PUD MASTER DEVELOPMENT PLAN
LAURA HEIGHTS
BEXAR COUNTY, TEXAS

A memo from the
CITY of SAN ANTONIO
Planning Department
Master Development

SUBJECT: # 05-035

Name: Laura Heights, PUD.

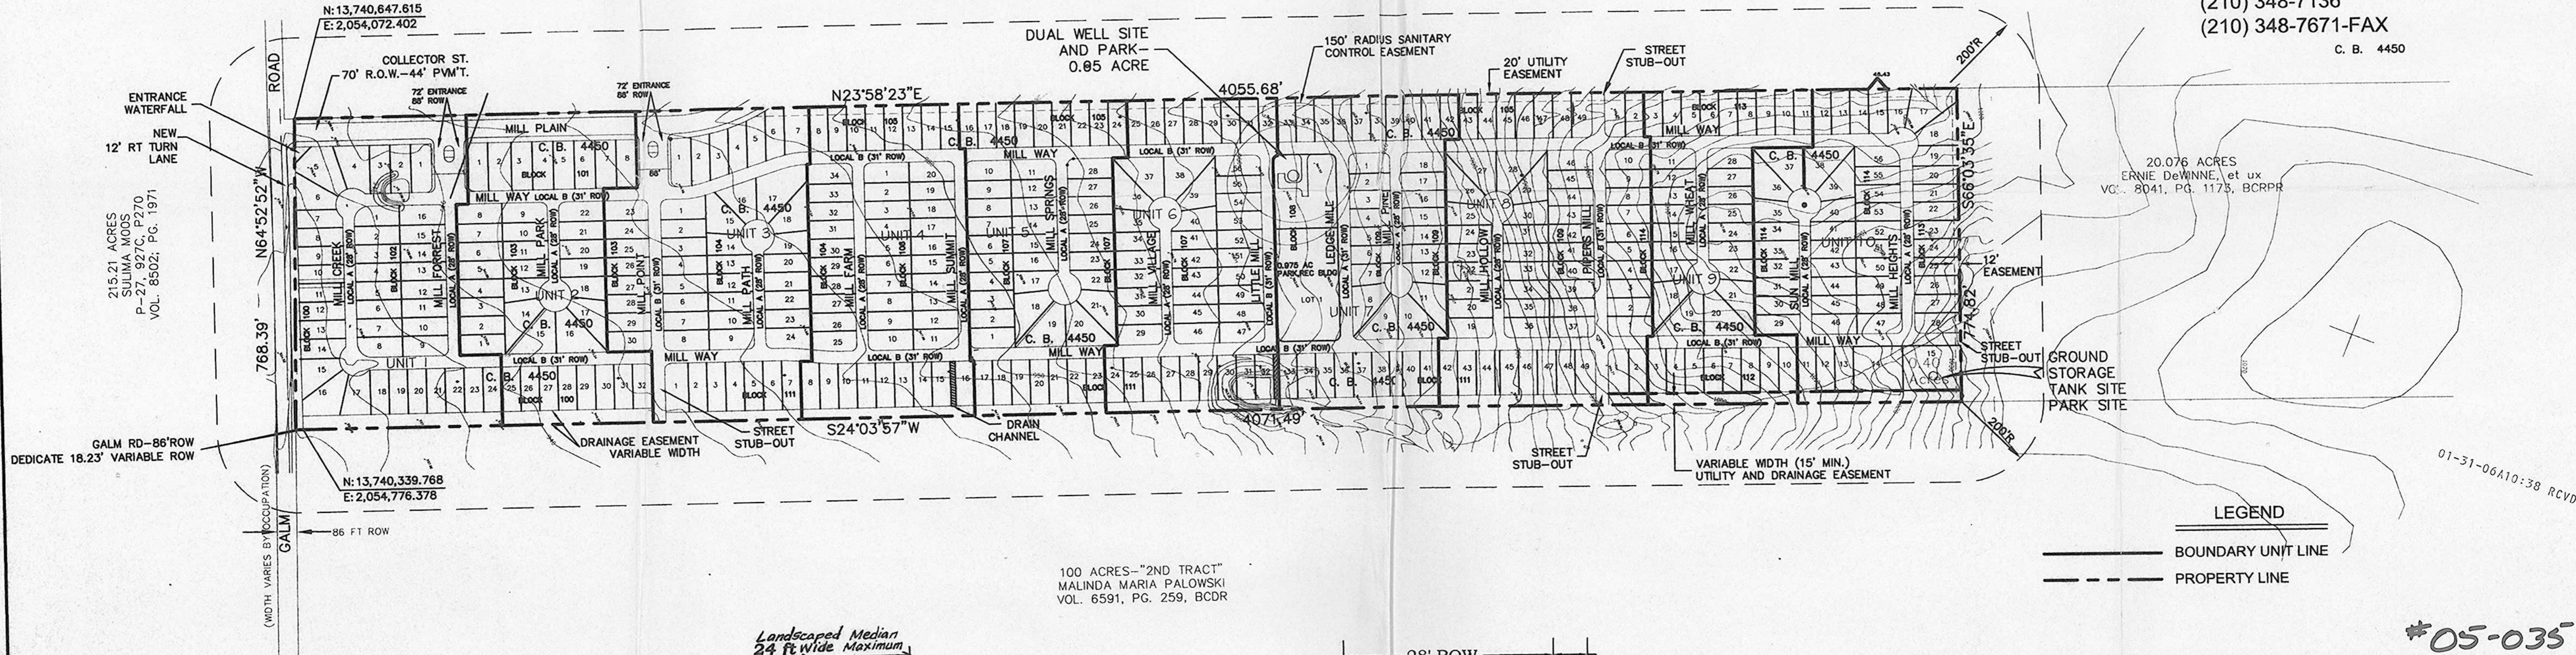
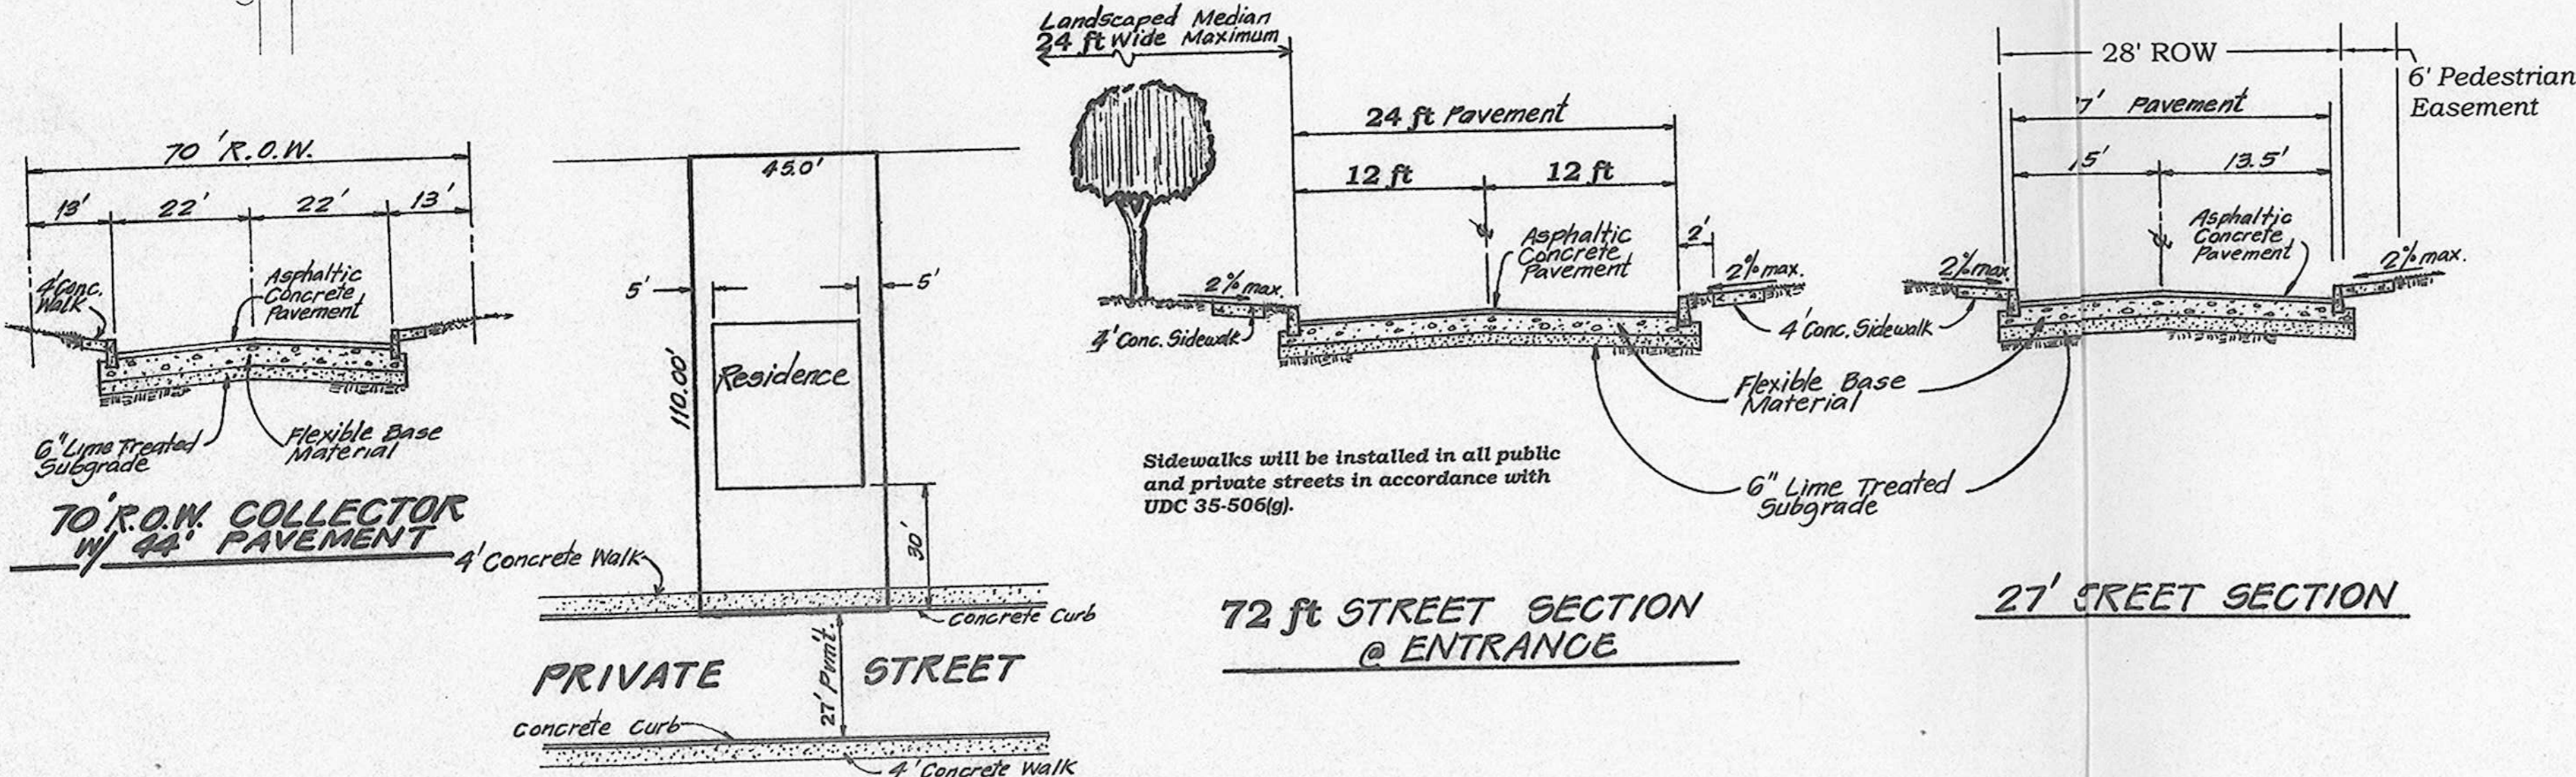
- **DSD – Traffic Impact Analysis & Streets** indicates the following requirements and on-site improvements are necessary and shall be provided by the developer, on and before the completion date of Laura Heights:

- All access roadways shall provide clear sight distance on all existing and proposed roadways in order to provide adequate obstruction free viewing distances for approaching traffic. All signage, landscaping, and improvements shall be selected and located so as to not block these clear sight distance areas.

- The developer shall be responsible for providing right-turn deceleration lanes as well as left turn lanes, with storage lengths and bay taper as it relates to the submitted TIA traffic counts, (Uniform Development Code (UDC) – 35-502(a)(7), subsection C.

- Sidewalks along all interior and exterior roadways are to be installed in accordance with UDC 35-506(q).
- **Parks** has indicated that amenities to be provided are as follows:

- Playground
 - Swimming Pool (2,500 sq.ft.)
 - Recreation Center
 - Athletic Courts
- **Bexar County** states the following improvements will be provided by the developer prior to completion of the Laura Heights Subdivision:

- Secondary access onto the public collector must be secured prior to the approval of any plat or combination of plats exceeding 125 dwelling units.
 - All decorative structures shall be placed within private property and not within public right-of-way.

- All traffic controls shall be warranted as per the Texas Manual on Unified Control Devices and approved by Bexar County.
